Applies To: **2000 Insight – ALL**
May 15, 2003
2001 Insight with M/T – From VIN JHMZE1...1T000001 thru JHMZE1...1T001923

Product Update: Insight Parking Brake Lever

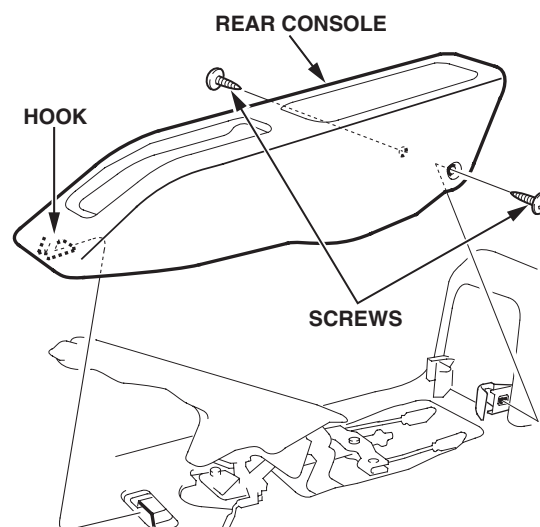
A weak support rod in the parking brake lever can cause the release button to stick. This condition makes the parking brake difficult to set, but it does not affect normal braking while driving.

Replace the parking brake lever.

Parking Brake Lever:
P/N 47105-S3Y-033ZA, H/C 6819478

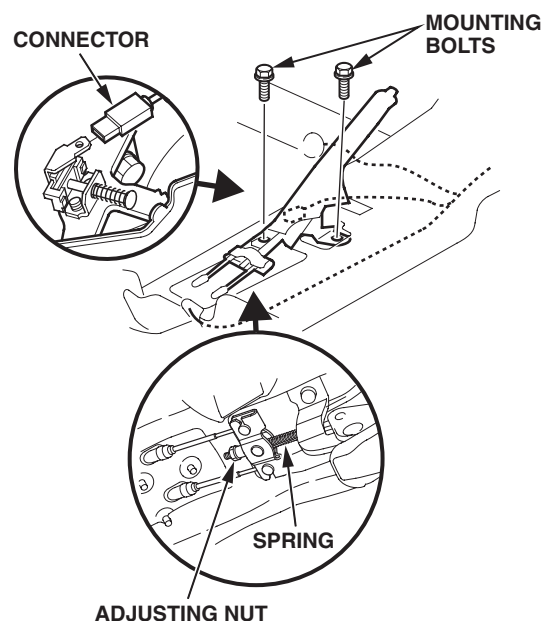
1. Remove the rear console:
 - Remove the two screws.
 - Move the console forward to detach it from the hook.

2. Remove the parking brake lever:
 - Remove the adjusting nut and the spring.
 - Disconnect the parking brake switch connector.
 - Remove the two mounting bolts.

3. Install the new parking brake lever, and torque the mounting bolts to 22 N·m (16 lb-ft).
4. Connect the parking brake switch connector, then install the original spring and the adjusting nut.
5. Block the front wheels, then raise the rear of the vehicle, and support it with safety stands.
6. Pull up the parking brake lever one click.
7. Tighten the parking brake lever adjusting nut until you get a slight drag on the rear brakes when you turn the rear wheels.
8. Release the parking brake lever. If the rear wheels don't turn freely, repeat steps 6 thru 8.
9. Lower the vehicle.
10. Install the rear center console.
11. Center-punch a completion mark above the tenth character of the engine compartment VIN.
